File #: IR-26-009, **Version:** 1

INFORMATION REQUEST (IR) - Bellerose Drive Condition

Requested by: Councillor Clark

Figure 1: Proposed “Spot Redesign” of Bellerose Drive at Northbound Merge Area

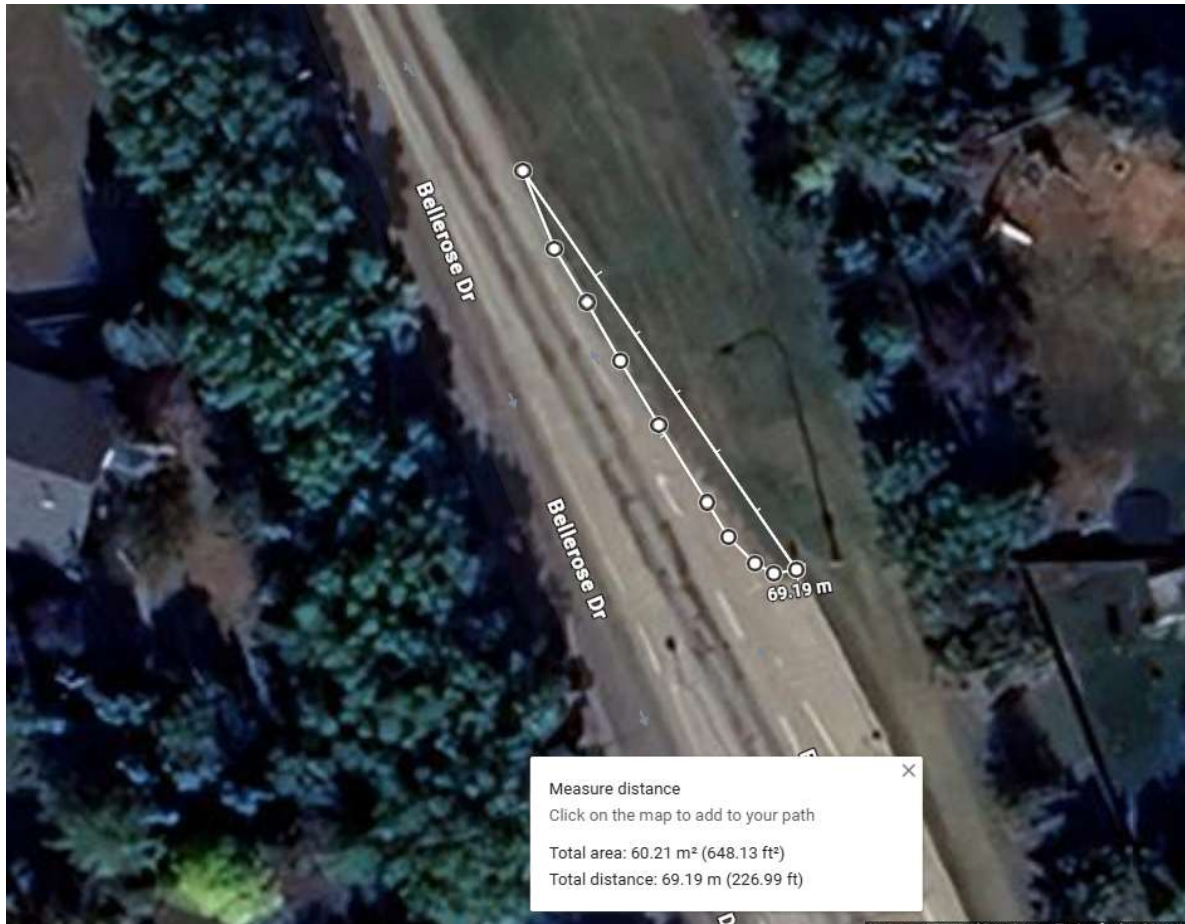
- B) In recognition of the experiences of Public Operations responding more frequently to focused areas and the specific areas of concern reported at the locations immediately north of the Oakmont Drive intersection, where the road transitions from two-lanes northbound to one lane; an alternative of response more aligned to a “spot redesign” may be a preferred option. The potential response of redesigning the final merge area and widening and reducing the “sharpness” of the lane end could result in improved roadway conditions and reduce the reported issue of vehicles leaving the road surface. An attachment to this report identified the conceptual area of the improvement and redesign area of the roadway and shoulder.

The response would require engineering and design work to be completed in advance of any construction (geotechnical investigation and testing of the area to ensure suitable material and design) that would inform on an improved accuracy of costs and would cost an estimated \$45,000 which represents an opinion of probable cost for the work to be \$30,000, with \$15,000 for engineering, design and construction management services. Within this cost is a 25% contingency due to the conceptual state of the proposed work.

The above highlights the location of the northbound Bellerose Drive lanes transitioning from 2-lanes to 1-lane and the area of focus proposed in Section 3B, where the merge area could be angled to improve merge flow and base work performed with asphalt work to deliver a wider shoulder at this site.

Conceptual opinion of probable costs = \$45,000
